LARGE CONSTRUCTION NOTICE OF INTENT (LCNOI) FOR COVERAGE UNDER THE LARGE CONSTRUCTION STORM WATER GENERAL NPDES PERMIT

FACILITY SITE NAME: Reunion Parkway Phase 2
FACILITY SITE ADDRESS (If the physical address is not available, please indicate the nearest named road. For linear projects indicate the beginning of the project and identify all counties the project traverses.)
STREET: Reunion Parkways at Bozeman Road to Parkwa East
CITY: Madison STATE: Mississippi COUNTY: Madiosn ZIP: 39110
FACILITY SITE TRIBAL LAND ID (N/A If not applicable): N/A
LATITUDE: 32 degrees 29 minutes 55.32 seconds LONGITUDE: 90 degrees 07 minutes 44.08 seconds
LAT & LONG DATA SOURCE (GPS (Please GPS Project Entrance/Start Point) or Map Interpolation):
TOTAL ACREAGE THAT WILL BE DISTURBED 1: 27

DESCRIPTION OF CONSTRUCTION ACTIVITY: New Roadway and Bridge Overpass Construction

BY	MISSISSIPPI DEPARTMENT OF TRANSPORTATION		
REVISION	EROSION CONTROL		
	REUNION PARKWAY		
	PRELIMINARY		
	NOT FOR CONSTRUCTION		
	PROJ. NO.: 105278		
	COUNTY: MADISON		
DATE	FILE NAME:	WORKING NUMBER	1
DESIGN TEAM	CHECKED	DATE	SHEET NUMBER
			1

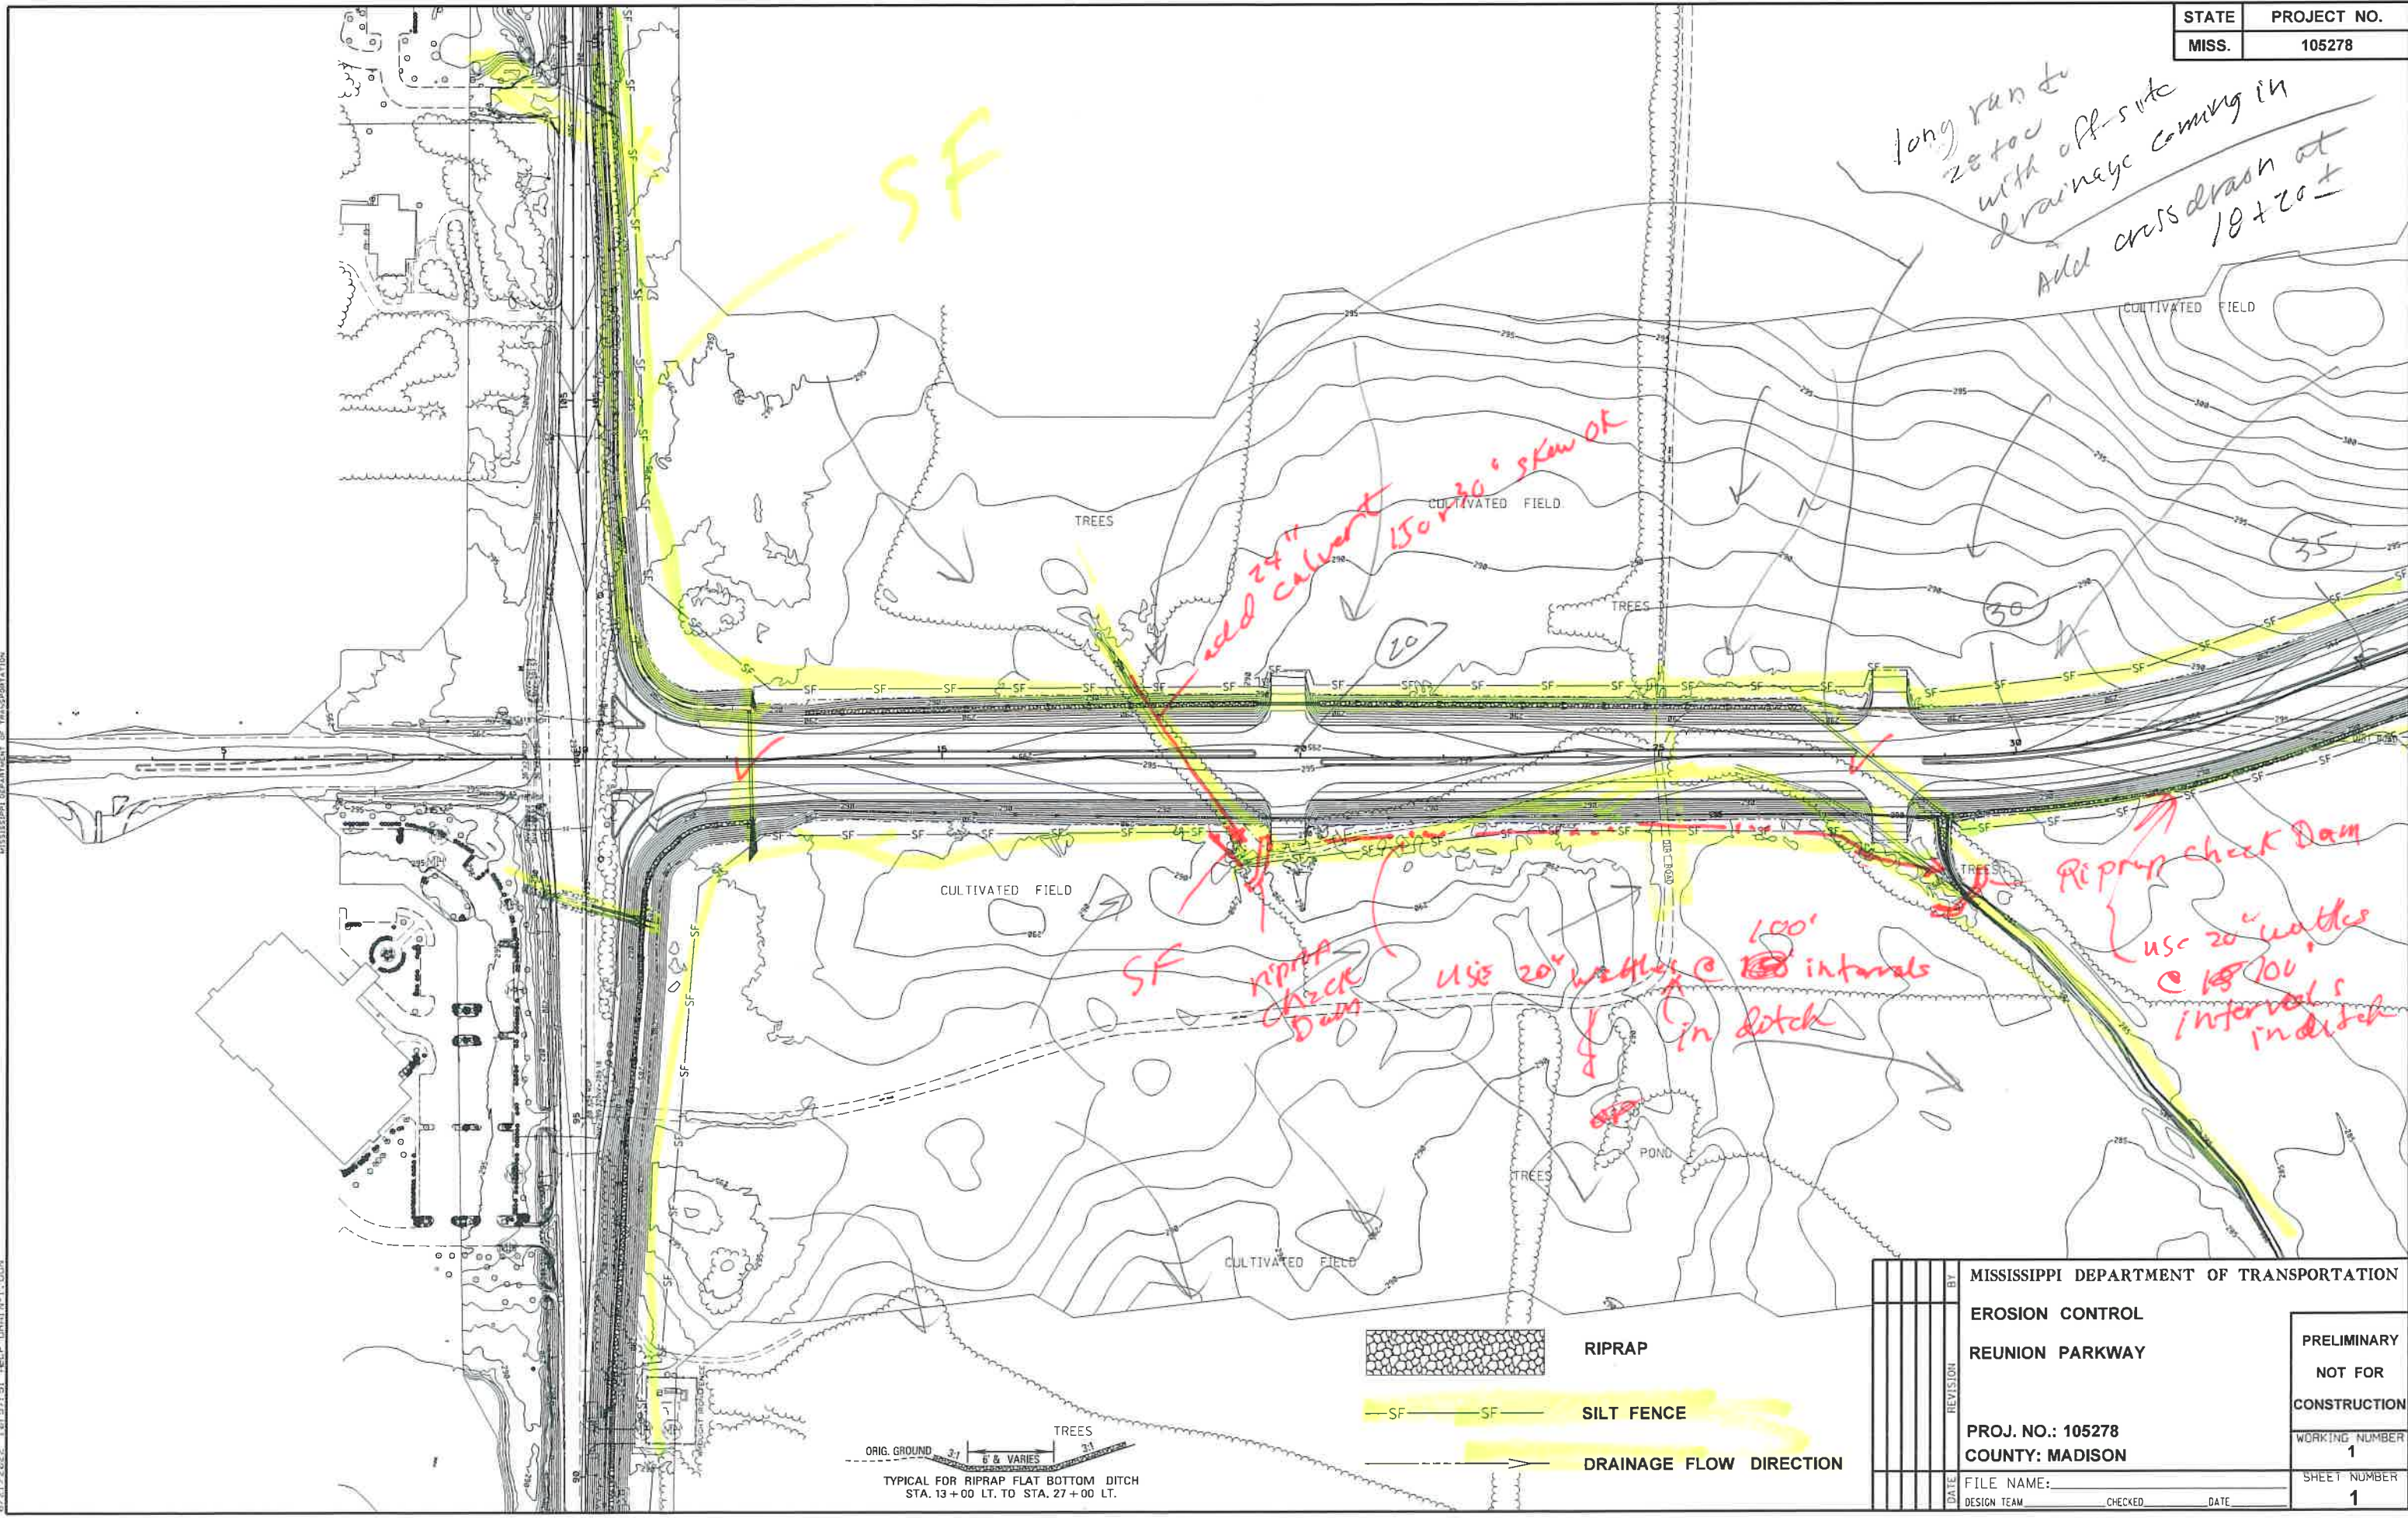
*long run to
28+00
with off-site
drainage coming in
Add cross drain at
18+20±*

add 24" culvert 150' x 30" skew OK

Riprap check Dam

SF riprap check Dam

use 20" waffles @ 100' intervals in ditch

use 20" waffles @ 100' intervals in ditch

PRELIMINARY
NOT FOR
CONSTRUCTION
WORKING NUMBER
1A
SHEET NUMBER
3

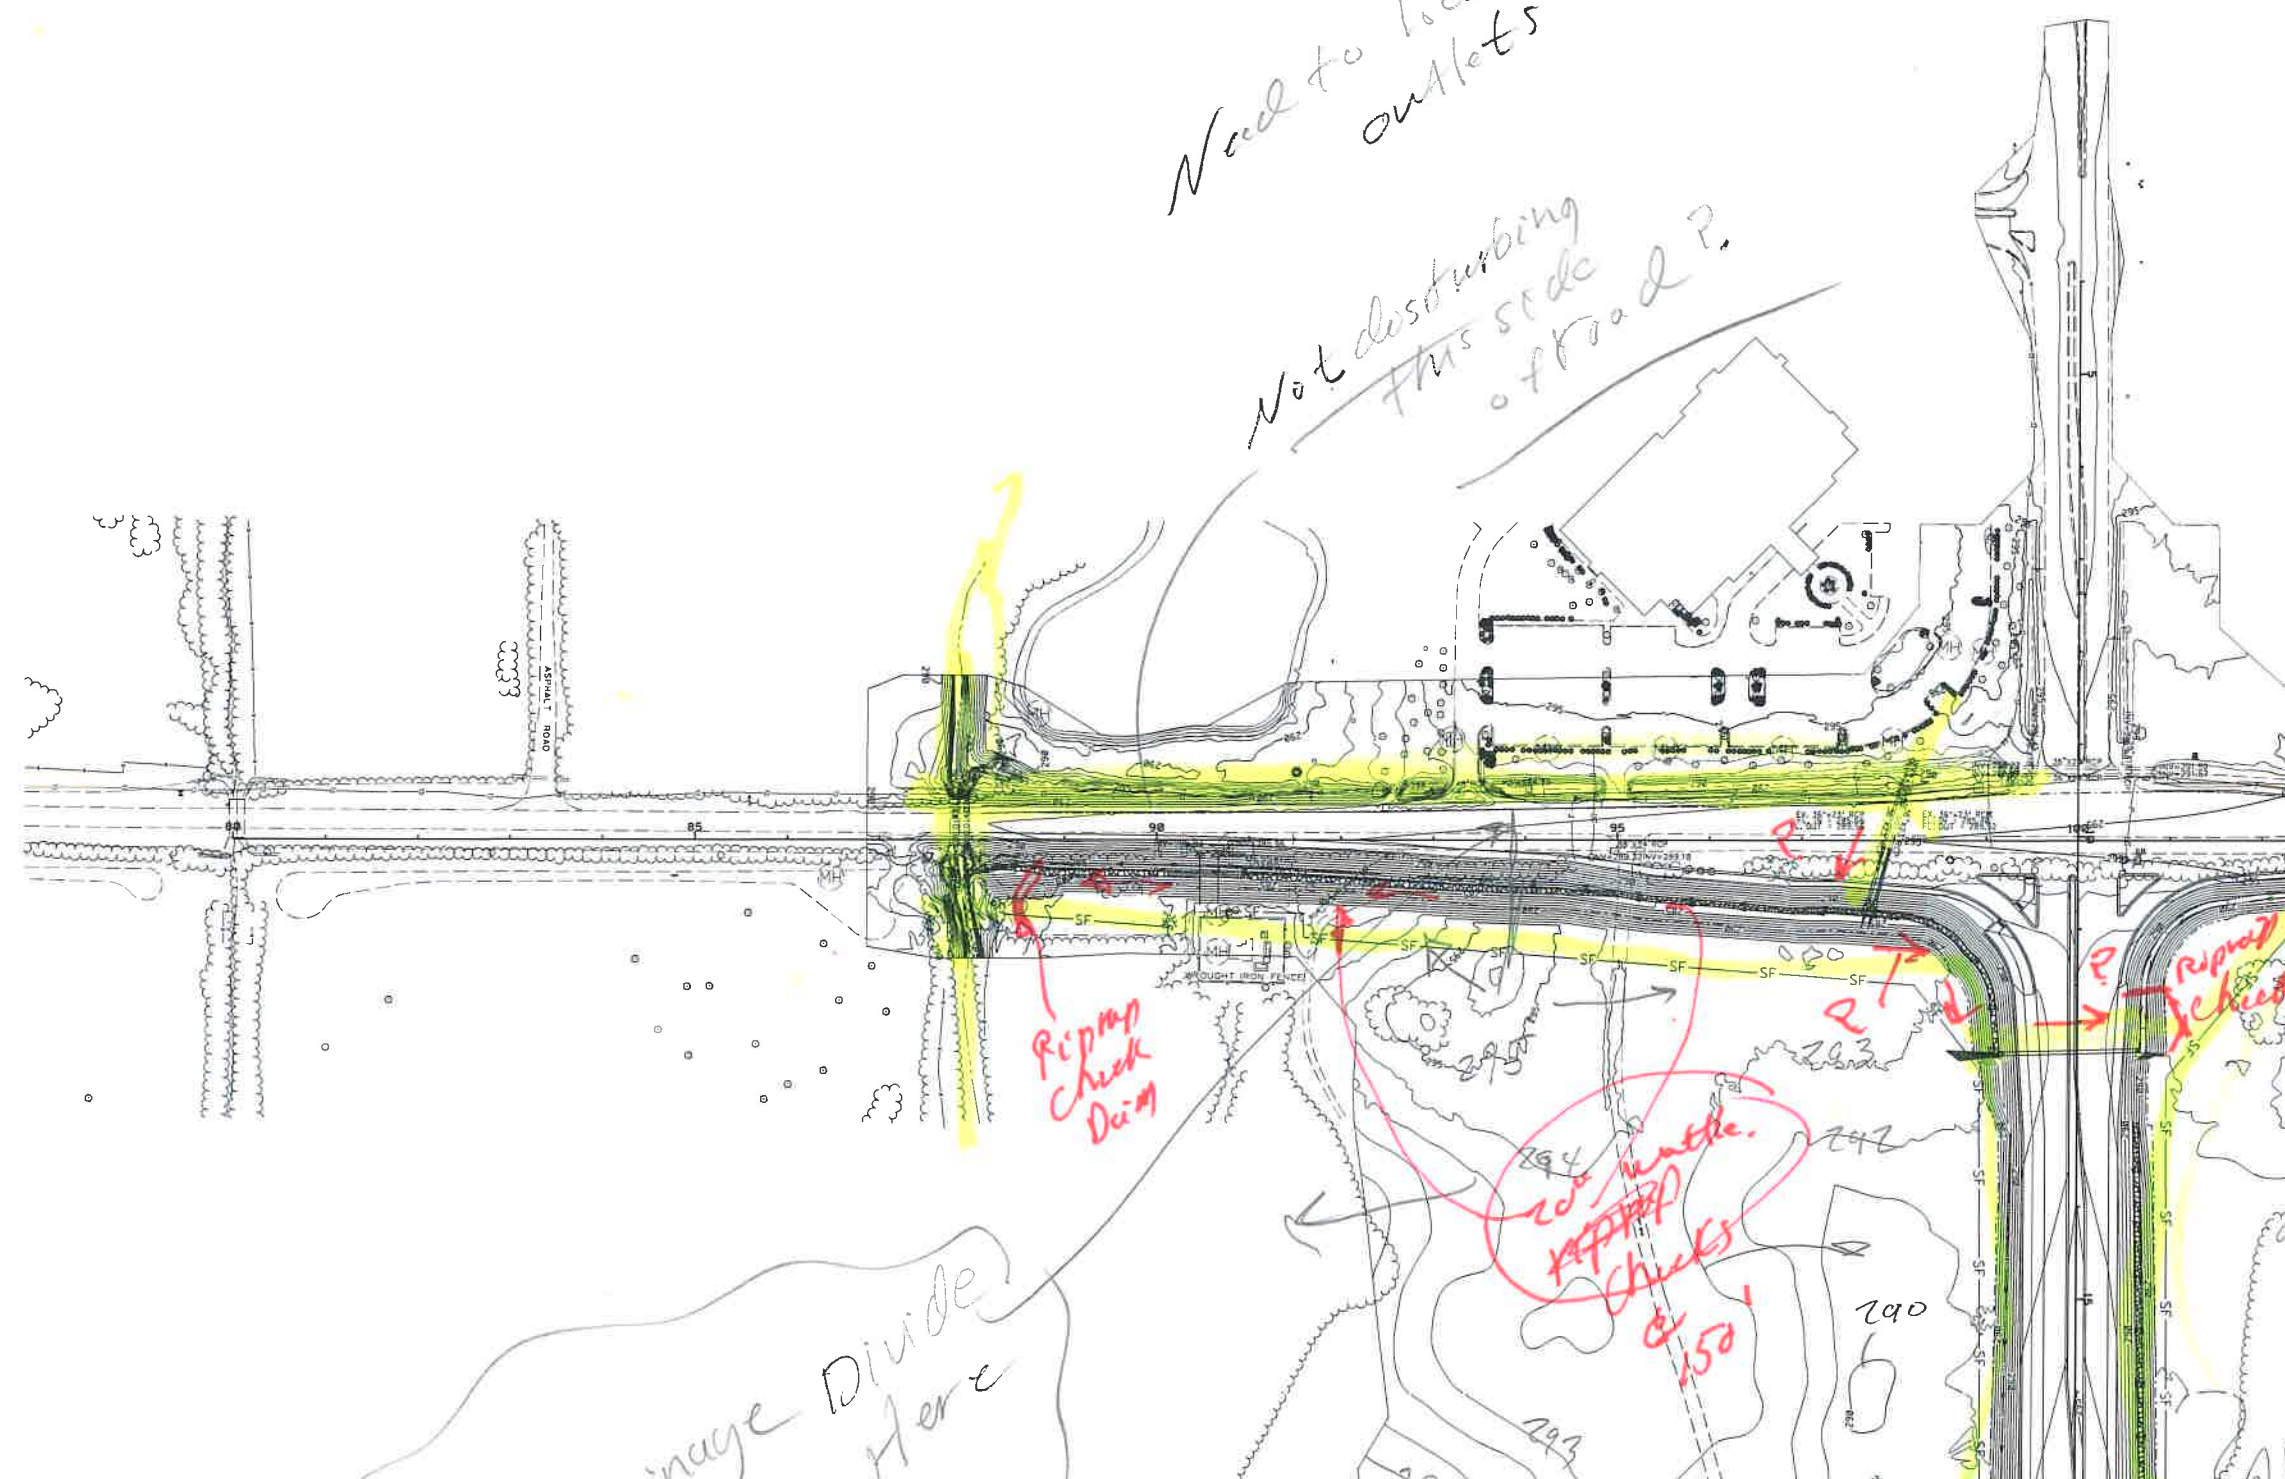
Need to locate outlets
Not disturbing this side of road?
